App. No. 09/779,788 Amendment dated 1/24/2005 Reply to Office Action of 07/23/2004

REMARKS/ARGUMENTS

Appl. No. 09/779,788 Amdt. Dated Jan. 24 2005 Reply to Office Action of July 23, 2004 **Annotated Sheet Showing Changes**

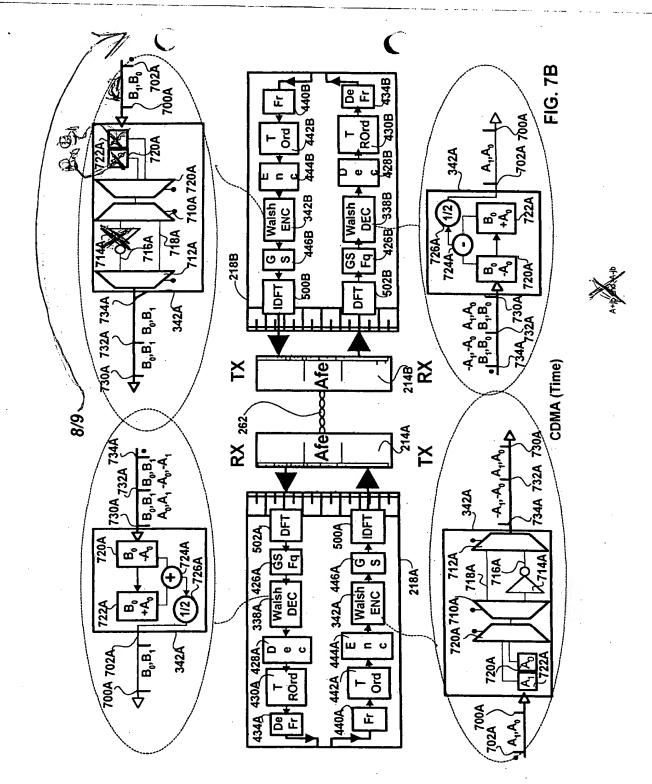
Applicant has submitted redline and replacement sheets for FIGS. 7A-7B to correct certain informalities and to remove the inverter in the Walsh encoder 342B to conform that circuit to the input and output frame sets in which no inversion is shown. "The Walsh code for the DSP 218B is orthogonal to that assigned to DSP 218A." (Specification at page 16, line 21-22, and page 17 line 20-21)

The attached sheets of drawings include changes to Figs. 7A and 7B. These sheets replace the original sheets including Figs 7A and 7B.
